Subject: Comment Letter – Sediment and Temperature TMDL in the Scott River Watershed.

Scott River TMDL Public Hearing Comments

The NCRWQCB has requested comments regarding the proposed Scott River TMDL dated September 19, 2005. I have reviewed the currently proposed Scott River TMDL and have the following comments and 41 recommendations to improve the TMDL. Many of my comments are similar to comments given to the NCRWQCB staff on August 12, 2005 as a Technical Advisory Group (TAG) member. I have summarized my comments below and if necessary can provide more detailed comments and copies of literature citations regarding these issues.

Example from French Creek THP 2-04-128: 2,800 feet of riparian zone harvested in 2000.

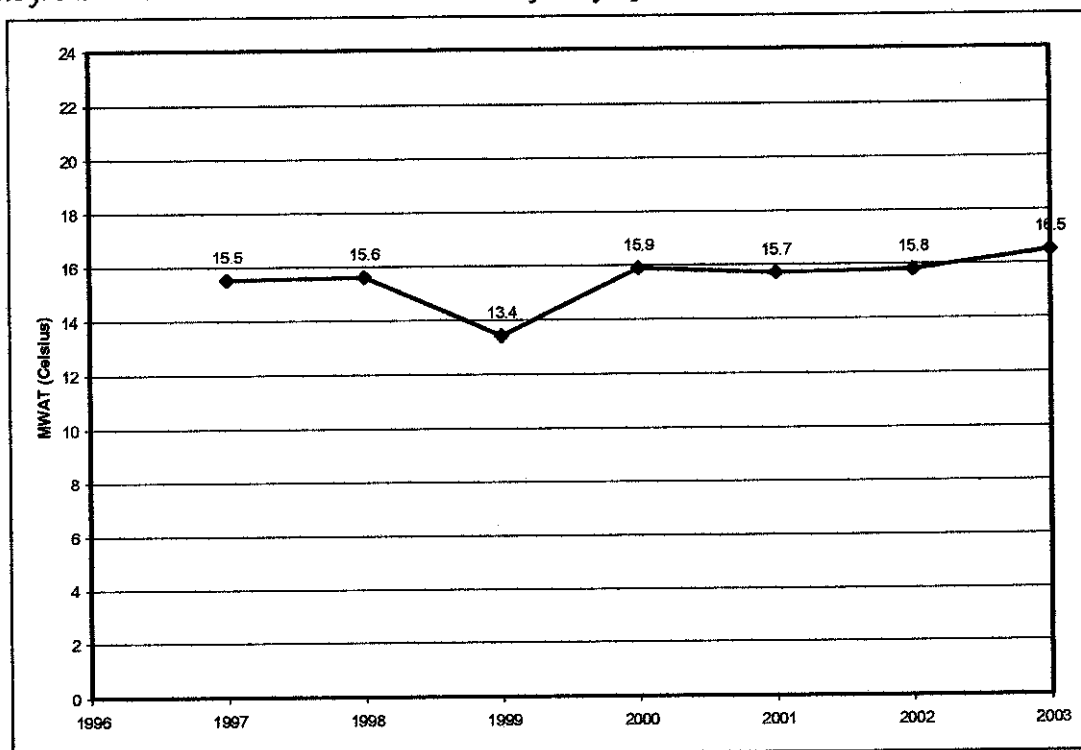
In the Scott River watershed in 2004, to better understand cause-and-effect relationships between riparian zone shade and stream water temperatures, seven years of stream temperature monitoring in French Creek was compared to the amount of riparian zone harvest during the same period (French Creek THP 2-04-128). The Upper North Fork of French Creek water temperatures (MWAT) remained unchanged between 1997 and 2004 during the harvest of 2,800 feet of Class I riparian habitat (see chart). The middle reach of French Creek MWAT stream temperatures remained unchanged during the harvest of 11,300 feet of Class I riparian habitat and 4,000 feet of Class II riparian habitat. The conclusions of the study found that stream temperatures in French Creek do not appear to have increased or decreased following timber harvest that retained either 70% canopy closure (Class I) or 50% canopy closure (Class II) (French Creek THP 2-04-128).

(Example from Etna Creek THP 2-05-138: 4,600 feet of Class I riparian zone harvest in 2002
11,600 feet of Class II riparian zone harvest in 2002.)

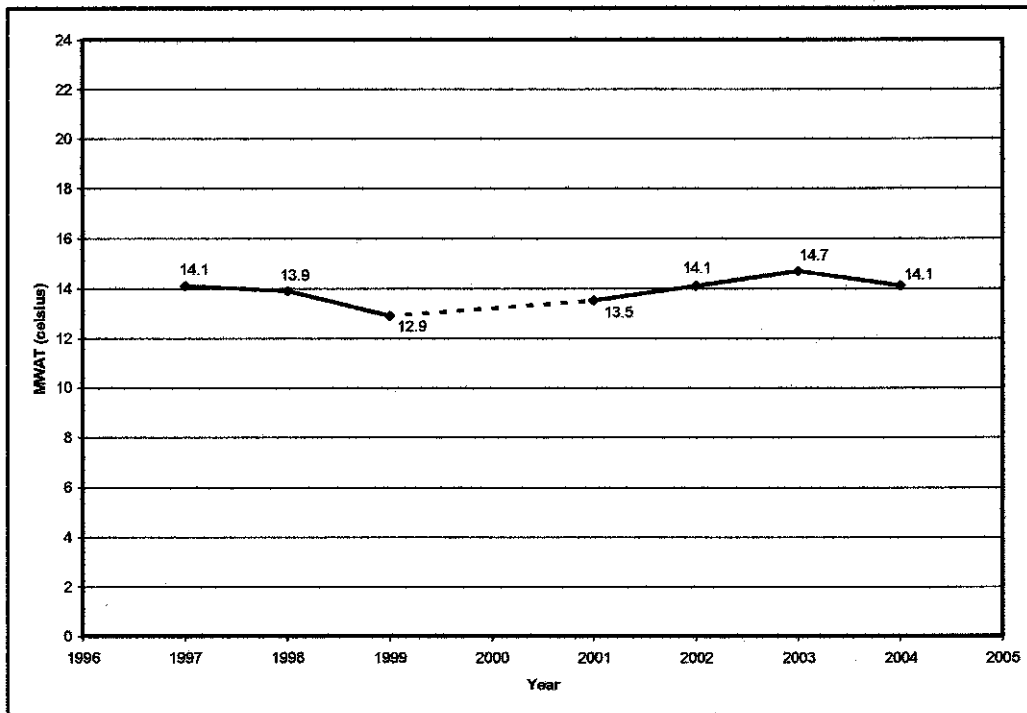
Another example of cause-and-effect monitoring in the Scott River watershed has been the timber harvesting within the Etna Creek watershed. For seven years of stream temperature monitoring in Etna Creek has been compared to the amount of riparian zone harvest during the same period (Etna Creek THP 2-05-138). Timber harvest in 1997 above the Upper Etna Creek station included 300' of Class II riparian zone that maintained 50% canopy closure. Timber harvest in 2002 above the Upper Etna Creek station included 11,660 feet of Class II riparian zone that maintained 50% canopy closure. Timber harvest in 2002 above the Upper Etna Creek station included 4,600 feet of Class I riparian zone that maintained 75% canopy closure. The Upper Etna Creek water temperatures (MWAT) have remained unchanged between 1997 and 2004 (see chart). Extensive timber harvest has also occurred above the Lower Etna Creek station and MWAT stream temperatures remained unchanged following the harvest. The conclusions of the study found that stream temperatures in Etna Creek do not appear to have increased or decreased following timber harvest that retained either 75% canopy closure (Class I) or 50% canopy closure (Class II) (Etna Creek THP 2-05-138).

Based on the results of regional studies (Alsea Watershed Study), the original Scott River Water Temperature report (Quigley *et al*, 2000) and results of modification of stream shade in French Creek we have found no cause-and-effect relationship between reduction of shade canopy and elevated stream water temperatures in forested watersheds. Based on these results, to improve the TMDL:

Recommendation #15: The NCRWQCB should review results of these studies and possibly other cause-and-effect studies to evaluate the apparent erroneous projections from stream temperature models proposed in the TMDL. This recommendation was also given to the NCRWQCB on August 12, 2005 as part of my Technical Advisory Group (TAG) member comments.
